PACKAGE 3.1
REACTIVITY CONTROL SYSTEMS
CROSS - REFERENCE
CURRENT TECHNICAL SPECIFICATIONS
TO
IMPROVED TECHNICAL SPECIFICATIONS

PRAIRIE ISLAND NUCLEAR GENERATING PLANT
UNITS 1 AND 2

Improved Technical Specifications
Conversion Submittal

Figure B 3.2.1B-1 (page 1 of 1)
K(Z) - Normalized F₀(Z) as a Function of Core Height

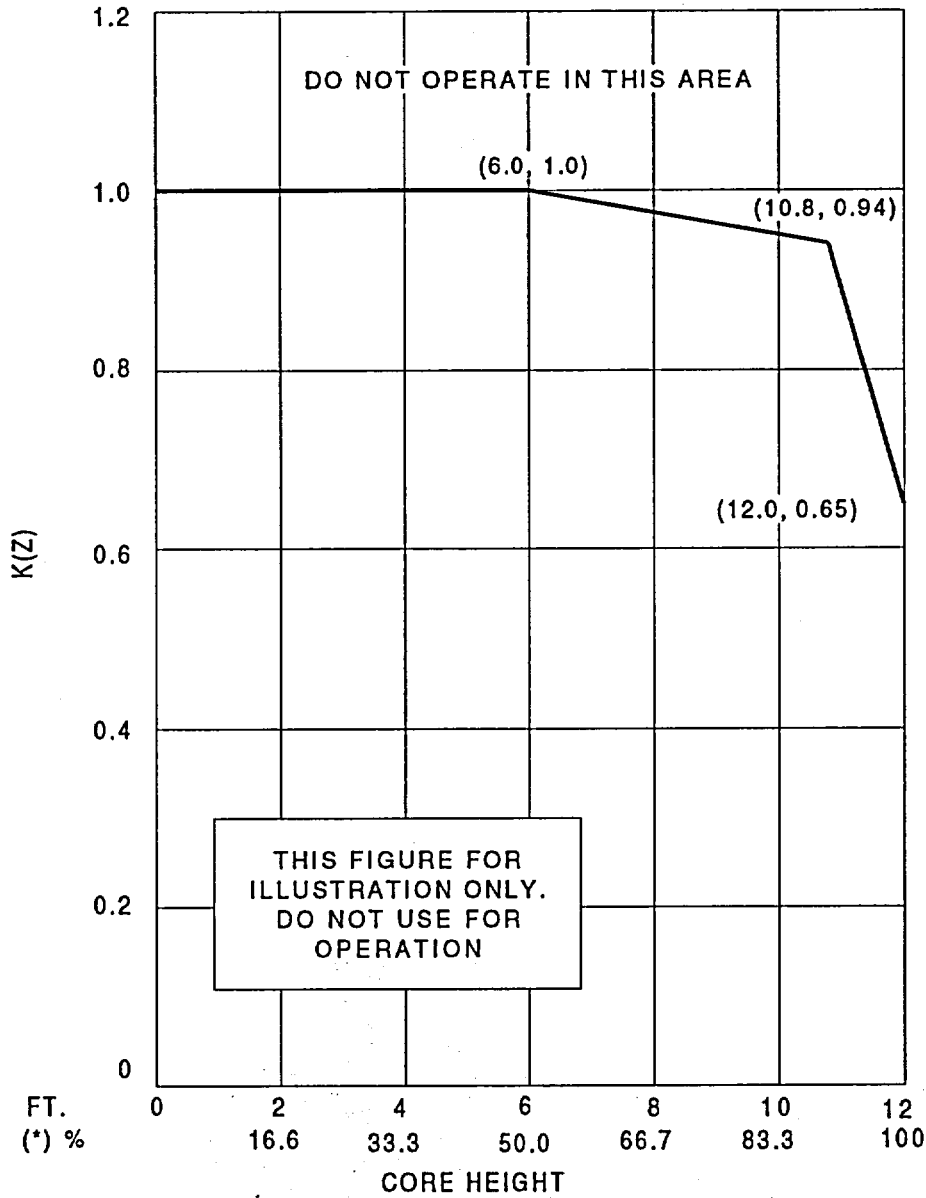
~~For this facility, the actual values of CFQ and K(Z) are given in the COLR; however, CFQ is normally a number on the order of [2.32], and K(Z) is a function that looks like the one provided in Figure B-3.2.1B-1.~~

~~Delete Figure~~

~~DELETED FIGURE~~

CL3.2-101

Figure B 3.2.3A-1 (Page 1 of 1)
AXIAL FLUX DIFFERENCE Acceptable Operation Limits
and Target Band Limits as a Function
of RATED THERMAL POWER

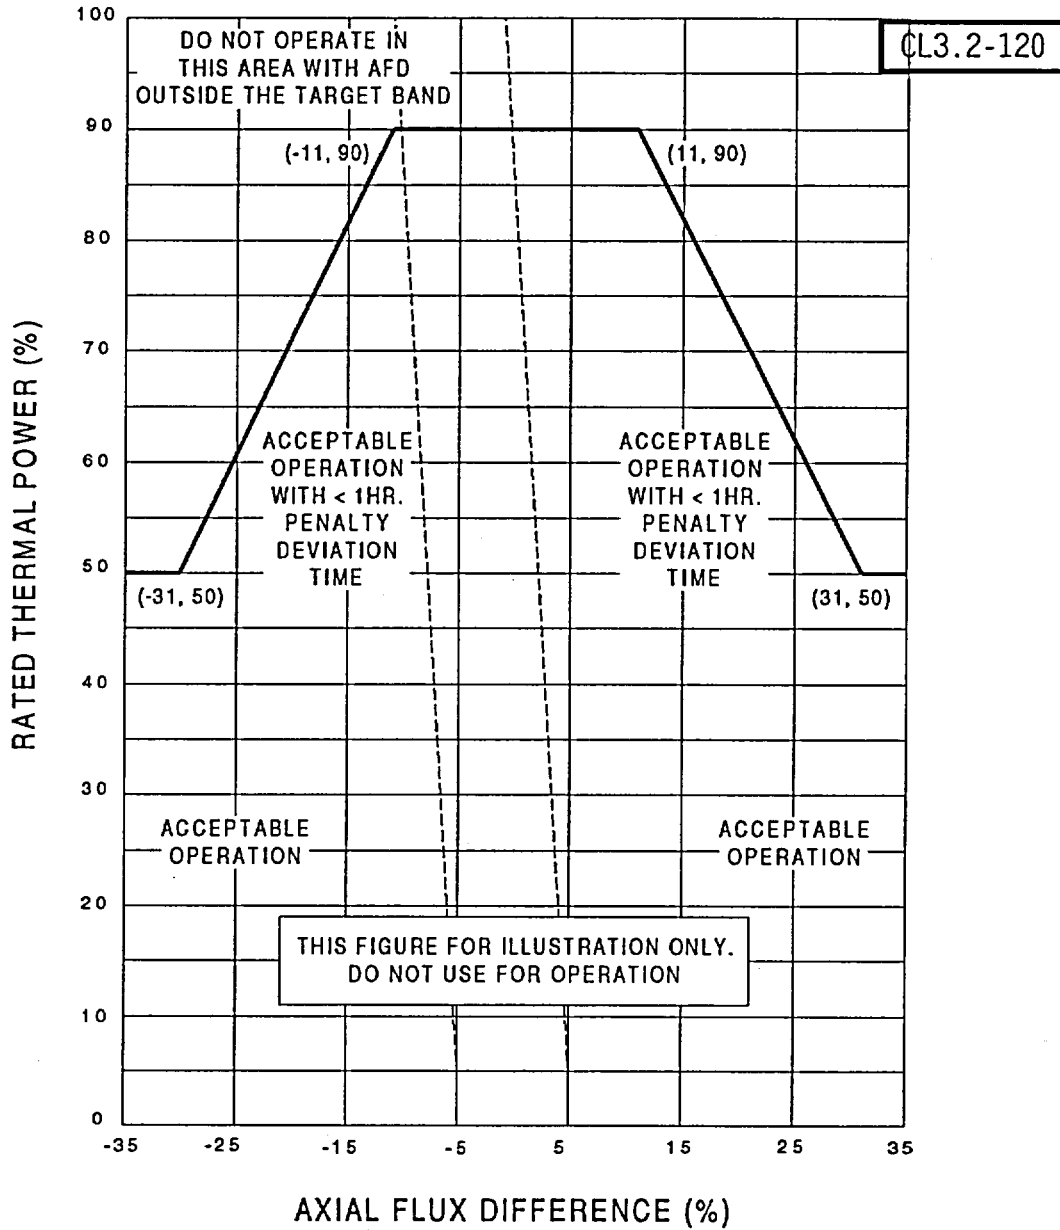
~~DELETE FIGURE~~

~~DELETE FIGURE~~
